Buildings - Bellary - Central Jail - Superintendent's quarters -

provision of hand pump to well - expenditure Rs. 550 - approved.

Water Supply - to the Superintendent's quarters - Central Jail, Bellary - Provision of a hand pump.

Buildings - Bellary - Central Jail - Superintendent's Quarters - Provision of hand pump to well.

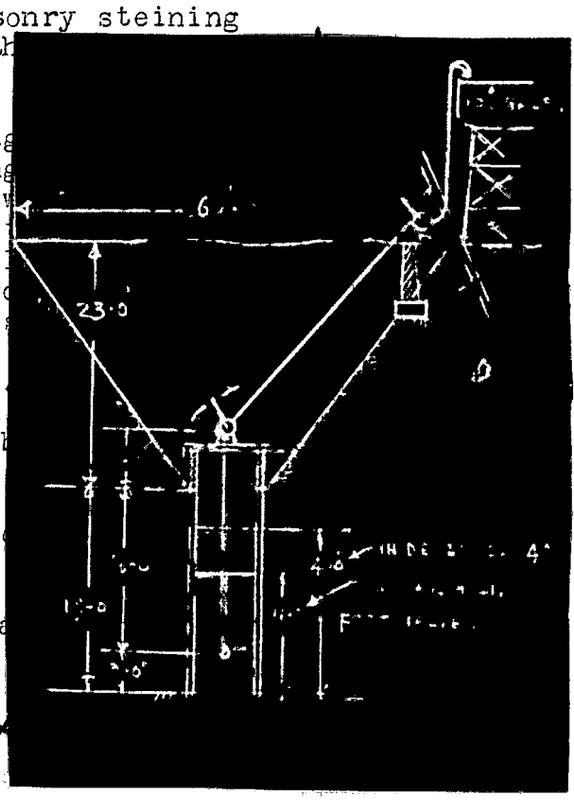
(3) The estimate for Rs.650/- has now been increased by the Superintending Engineer to Rs.800/- making provision for a second platform to suit the highest water level. The lower platform has been proposed by him at 25 feet above the bottom of the well, or 22 feet above the foot-valve. The suction head may, preferably, be limited to 20 feet as a maximum, against 22 feet in the present case..

The depth of water in December last was noted as 14 feet. The M.W.L. is not stated. If it does not go above the top of the existing masonry steining which appears to be 19 feet above bottom, a second platform would not be necessary.. The second platform should be omitted if it is considered unnecessary.

(4) The heights of existing masonry steining noted in the sketches at pages 17 & 21 (13) of th file, do not tally with each other.

(5) In the revised sketch at pag current estimate file, the existing masonry steining shown as being raised and the sides filled w locate the 2nd (L.E.) higher platform. But provision made for this in the estimate. that the types of pumps proposed are semi-ro pumps. If a second platform is found nece the pumps are of semi-rotary type, there is to a cheaper arrangement as shown in margin then no necessity to raise the steining and sides. Hence, provision for this has not b the estimate. The Superintending Engineer such an arrangement is feasible, and obtain corrected working estimate and plan from th Engineer before execution for his approval.

(6) The estimate for Rs.800/- ma subject to the above remarks.
